Task 30  
Sump 1727  
Interim Response Action  
Alternatives Assessment  
Final Report  
Version 3.2

APPENDIX A -- COMMENTS AND RESPONSES TO THE TASK 30 SUMP 1727  
INTERIM RESPONSE ACTION ALTERNATIVES ASSESSMENT  
DRAFT FINAL REPORT, MAY 1988

Re: Rocky Mountain Arsenal, (RMA),  
Task 30, Sump 1727 Interim Response  
Action, Alternatives Assessment,  
Draft Final Report, May, 1988.

Figure 3.3-1  
POTENTIAL SOURCE AREAS  
SOURCE: ESE, 1987

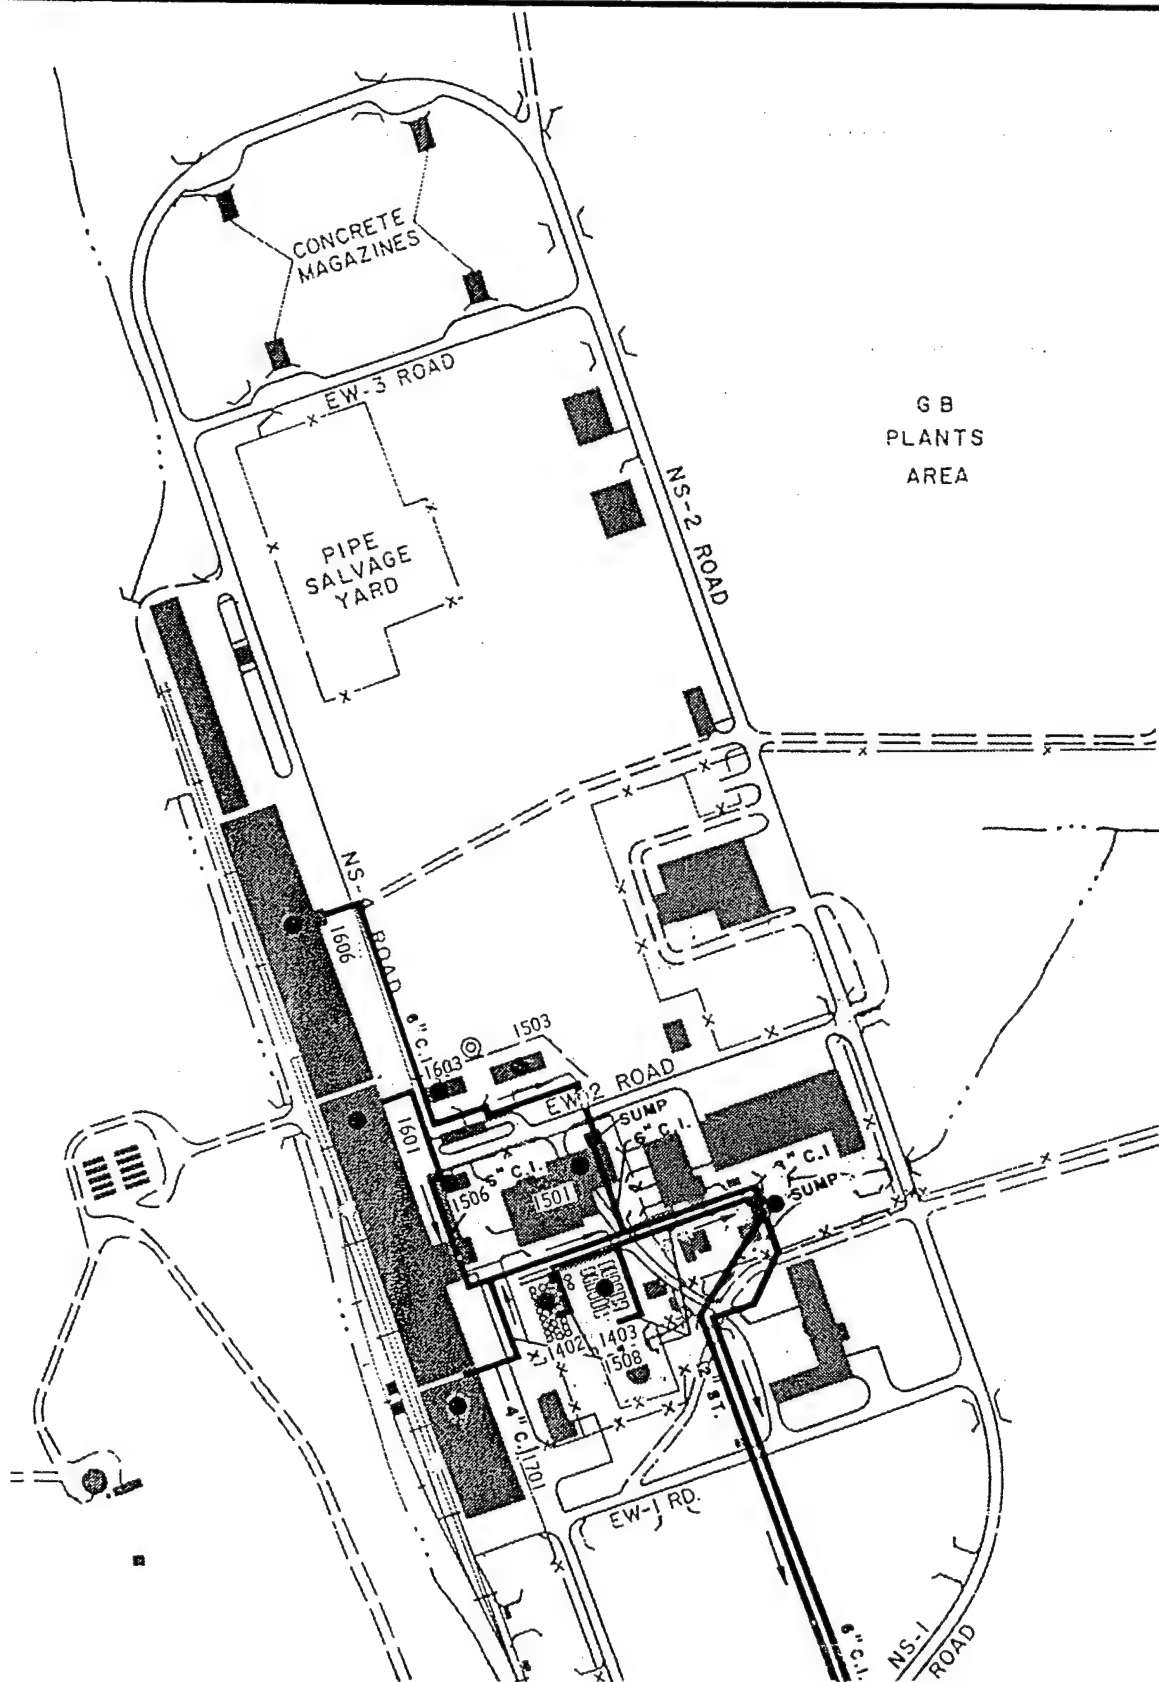
5. Page 3-11, Figure 3.3-1.
